SERVICE BULLETIN

ENGINE - MAIN GEARBOX ASSEMBLY - MODIFICATION OF O-RING FOR THE ANGLE GEARBOX SUPPORT - CATEGORY CODE 6 - MOD.ENG-72-0301

V2500-ENG-72-0301

Angle Gearbox Support
Fig.1

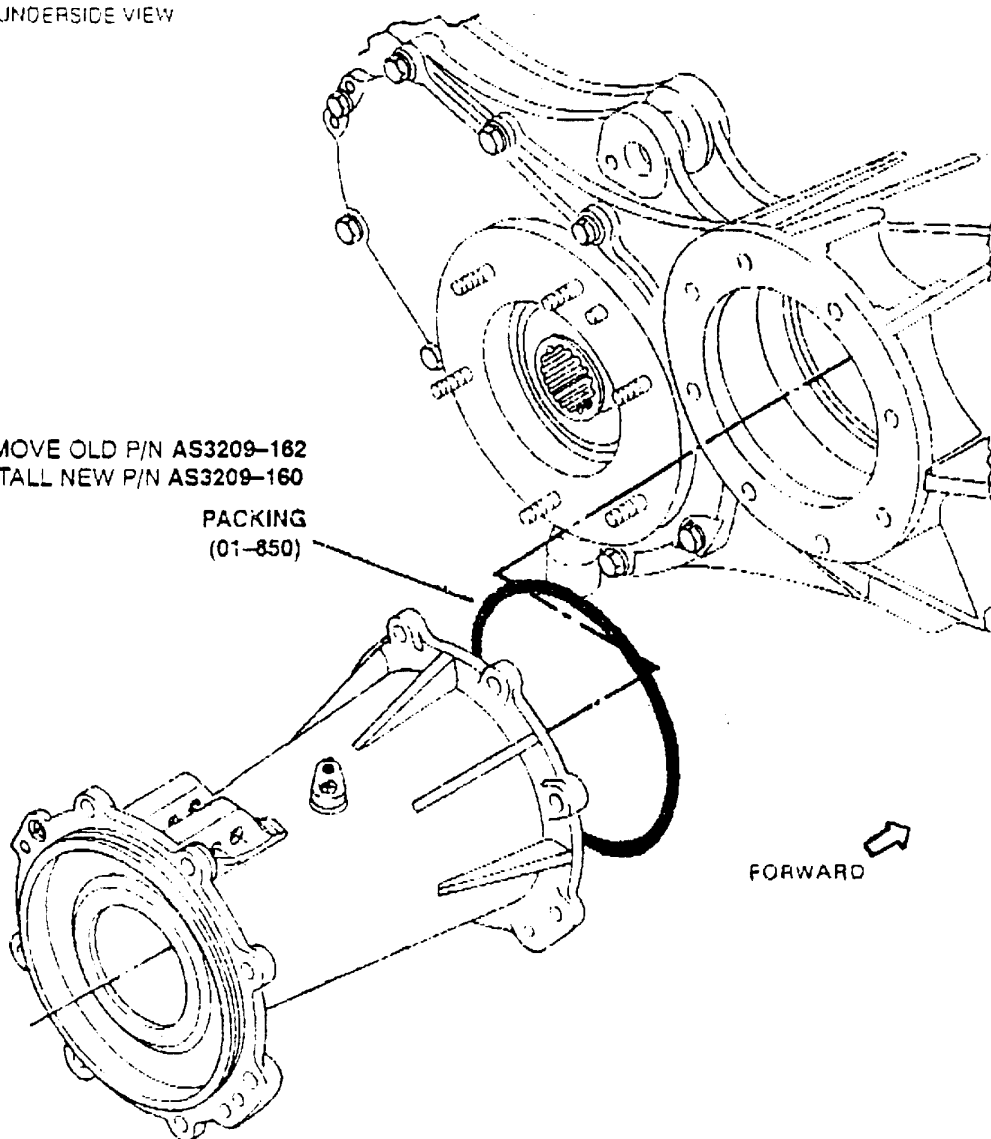
This Service Bulletin introduces a revised toroidal sealing ring. To decrease the compression, the cross section of the sealing ring has decreased from 0,314 mm to 0,187 mm.

REMOVE OLD P/N AS3209-162
INSTALL NEW P/N AS3209-160

- (1) Install the new Packing AS3209-160 (Refer to V2500-D5 Engine Manual (EM), Chapter/Section 72-60-10, Disassembly/Assembly).
